Revision of Figure 33-14 v110

Lennart Yseboodt, Matthias Wendt

Philips Research

September 17, 2015

Figure 33-14—POWER_ON state, per pairset operating current templates

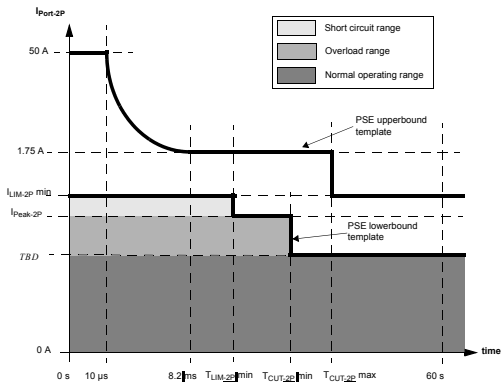
Figure 33-14 together with Equations 33-6 and 33-7 tie together many parameters from Table 33-11. This Figure has been mostly untouched, except for the '-2p' addition. Some issues need to be addressed.

1. There is a TBD in the lowerbound template. We need a way to express unbalance effects in a clear way.
2. $T_{LIM-2Pmin}$ has a value of less than 8.2ms for Type 4
3. Type 4 is limited to sourcing no more than 99.9W, this cannot be expressed by constant current
4. Single and Dual Signature PDs will have a different lowerbound template
5. $I_{LIM-2P(min)}$ is used twice in the Figure, for both the lower and upper template. By making $I_{LIM-2P(min)}$ class-based, the optional I_{CUT-2P} limit is no longer optional.

- ▶ Three new Figures presented to replace Figure 33-14
- ▶ Covers all cases (4 Types, 2 Signatures, 2/4 pair mode)
- ▶ Unbalance is shown in a simple intuitive way
- ▶ All issues on slide 3 are addressed

Figure 33-14a (2 pair & dual-signature)

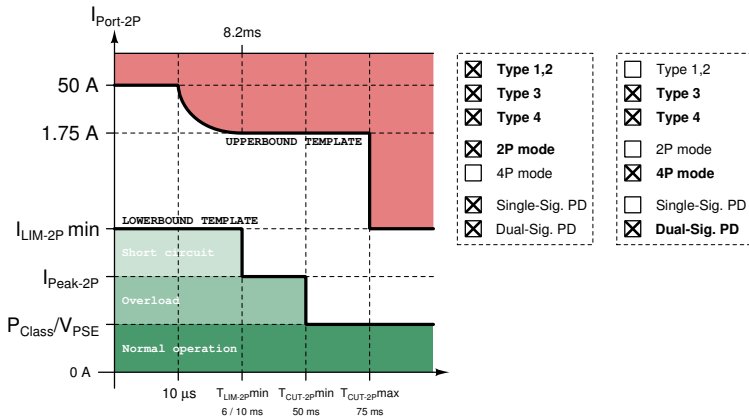
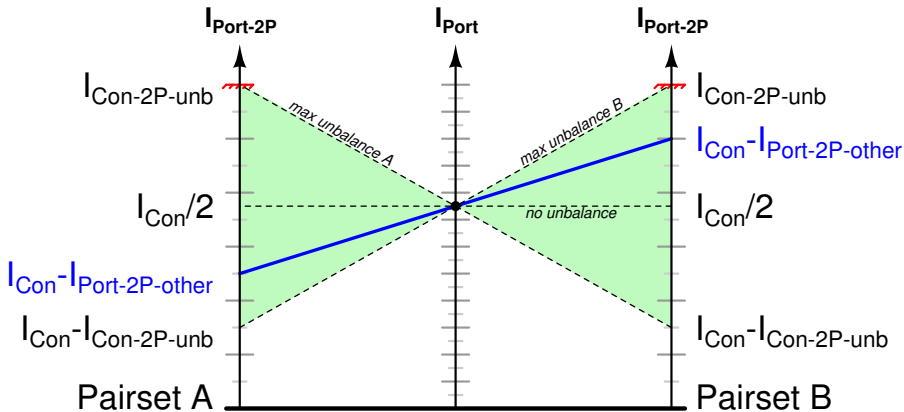
Applies to all PSEs in 2-pair mode, as well as PSEs connected to dual-signature PDs.

PSEs connected to a single-signature PD shall meet I_{Con} and $I_{\text{Con-2P_unb}}$ as specified in Table 33-11. PSEs connected to a dual-signature PD shall meet I_{Con} on each pairset as specified in Table 33-11.

P_{Class} applies to the full power at the PI, but is treated on a per pairset basis for dual signature PDs. The same method is appropriate for I_{Con} , it applies to each pairset independently when connected to a dual signature PD.

Figure 33-14b (Type 3, 4-pair, single-signature)

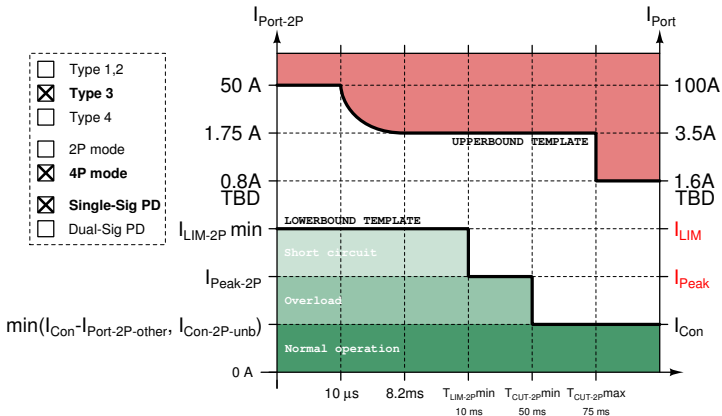
Applies to Type 3 PSEs, operating 4-pair mode, connected to single-signature PDs.

$$\text{Minimum pairset current} = \min(I_{Con} - I_{Port-2P-other}, I_{Con-2P-unb})$$

Figure 33-14c (Type 4, 4-pair, single-signature)

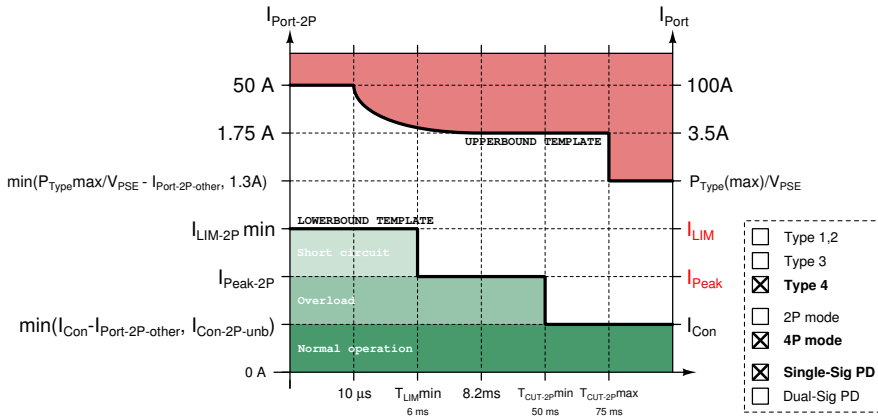
Applies to Type 4 PSEs, operating 4-pair mode, connected to single-signature PDs.
